## Replies to reviewer comments #1

A very interesting and useful contribution on the consequences of using long sampling lines in single-filter atmospheric radon measurements. A simple method is developed, and verified both in the laboratory and field, for correcting single-filter radon measurements for the effects of losses due to deposition of aerosol-attached radon progeny onto the walls of inlet tubes of varying lengths up to 200m. The results are discussed with reference to a number of possible aerosol deposition mechanisms inside tubing, with the outcome that the technique is both supported theoretically and has its limitations specifically identified and quantified. The prospect that inlet tubing deposition effects can be accurately corrected will reduce an important source of uncertainty in single-filter radon measurements, and expand the list of potential applications for these (relatively compact) detectors to include tall tower sites. This manuscript falls within the scope of AMT and describes topical original research worthy of publication. Furthermore, the manuscript is for the most part clearly written and well structured. I therefore recommend acceptance, after atte

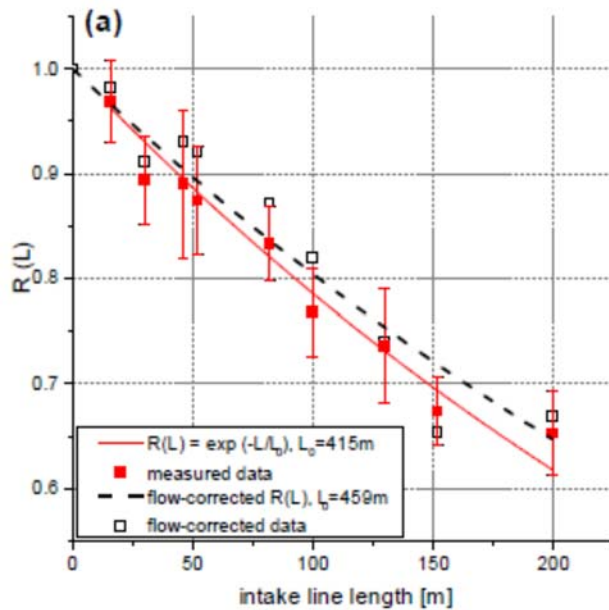
P4, L3: It would be nice to know if there are any ambient temperature or humidity effects on deposition rates, but I guess this was out of the scope of your study. However, I would have thought that it would be fairly easy to test the effects of different flow rates, especially given the expected strong dependency on  $Q$  (see Eq. 3). Did you investigate flow rate sensitivity?

Unfortunately, we did not test experimentally the dependency of flow rate on aerosol loss in the tubing, and you are correct about the rather strong dependency of the loss, based on Equation 3 and 4, (much less though on Eqs. 5a and b). Based on these four equations, we have now estimated the effect of flow rate differences from  $1 \text{ m}^3 \text{ hour}^{-1}$  in our laboratory experiments with the different line lengths (and pumps used). The maximum theoretical deviation of loss (6.8%) occurred at a flow rate

of  $1.4 \text{ m}^3 \text{ hour}^{-1}$  with the 100m line. Note that a flow rate of  $1 \text{ m}^3 \text{ hour}^{-1}$  ( $\pm 10\%$ ) was used in all experiments with lines longer than 100m. To take this effect into account for the general loss correction (Eq. 2), we have now added in Figure 2 corrected values that have been adjusted to a nominal flow rate of  $1 \text{ m}^3 \text{ hour}^{-1}$  as well as a second fit curve through these corrected values. As all flow rates for line lengths  $\leq 100 \text{ m}$  were higher than  $1 \text{ m}^3 \text{ hour}^{-1}$ , all these adjustment are positive and the characteristic length  $L_0$  of the fit curve is about 10% larger ( $L_0 = 459$  versus 415). When using the adjusted fit curve for  $R(L)$  this would lead to a maximum difference in the loss correction of 4.5% with a 200m line. The revised Figure 2a is displayed below.
